Friday 27th March 2020

REF: *Planning Proposal*
At 36 Lonsdale Street and 64-70 Brenan Street, Lilyfield

Maximum Building Height.

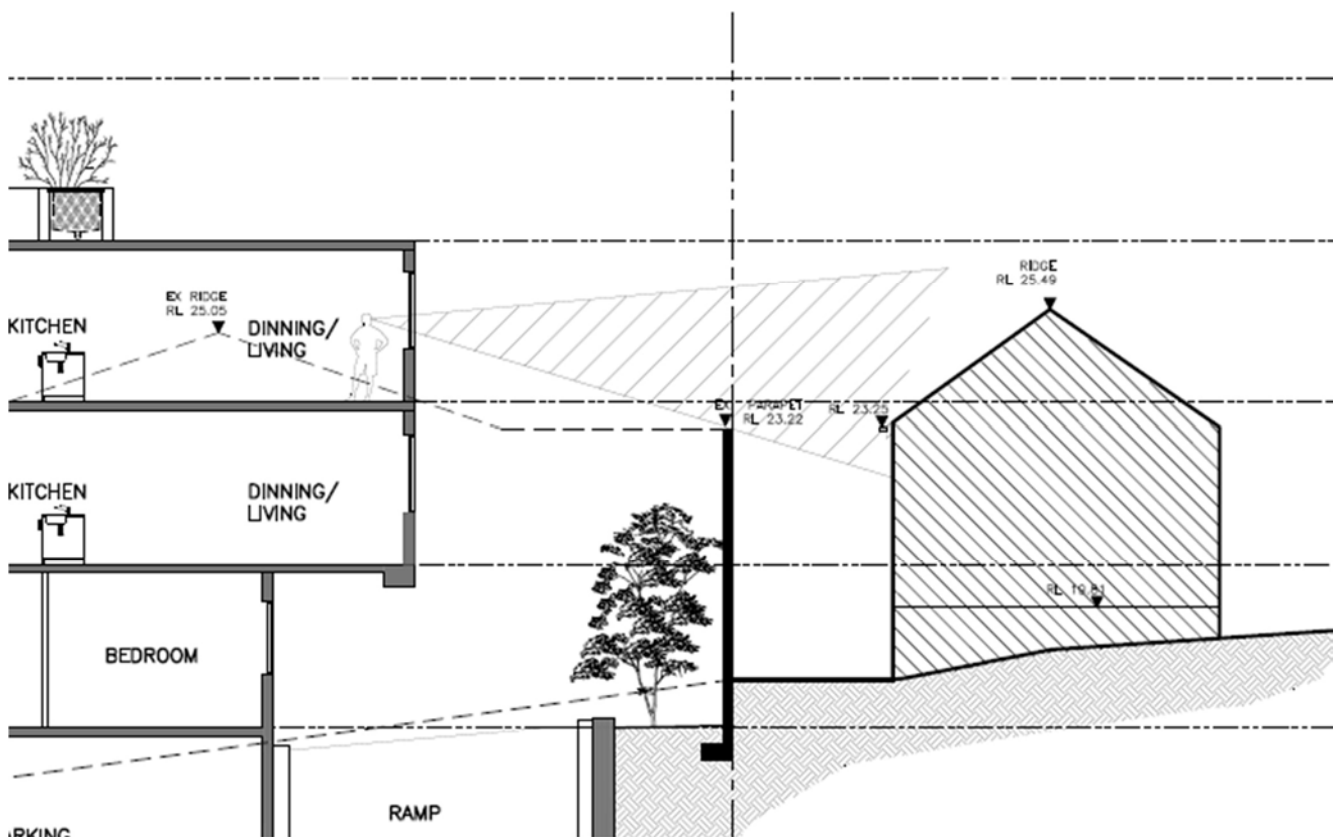
As discussed above, the current design adopts the maximum building height established by Council of RL33.2 which provides a buffer of 1.2m for building elements well above the figure of 500-700mm discussed in your letter.

The proposal as amended provides a suitable in the context of the IGA building, does not overshadow adjoining properties and includes increased setbacks to address overlooking. All which is absent from your analysis. It is also disappointing that Council when considering transition has not taken into consideration the 3-4 storey building at 13-29 Russell Street and rather focused on single storey dwellings only at the exclusion of potential transition in the future for larger building forms.
